Hi-Fi Products
Service Bulletin

Model: MDR-IF5K

No. 254

Subject: Charged Battery Does Not Last

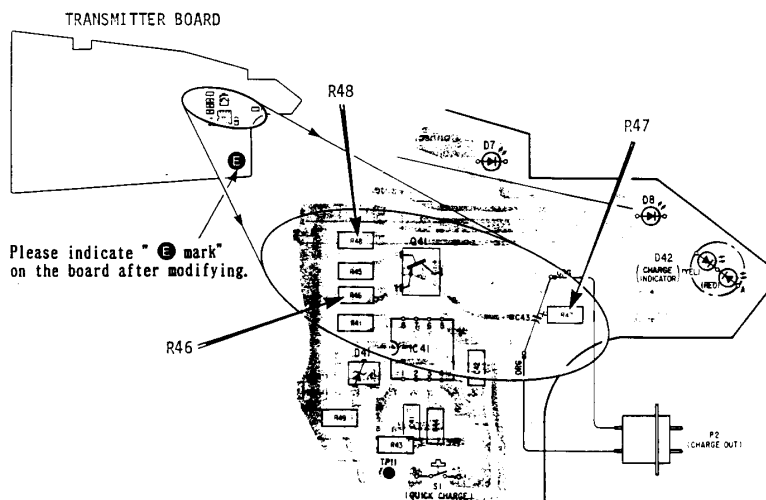
Symptom:
(11)

The battery only lasts two hours after repeated 3 hours quick charge.

Solution: Replace the chip resistors on TX Board with the following:

REFERENCE	DESCRIPTION		PART NUMBER
	FORMER	NEW	
R46	150 OHMS	100 OHMS	1-216-174-00
R47	100 OHMS	0 OHMS	1-216-296-00
R48	3.9 OHMS	1.5K	1-216-202-00
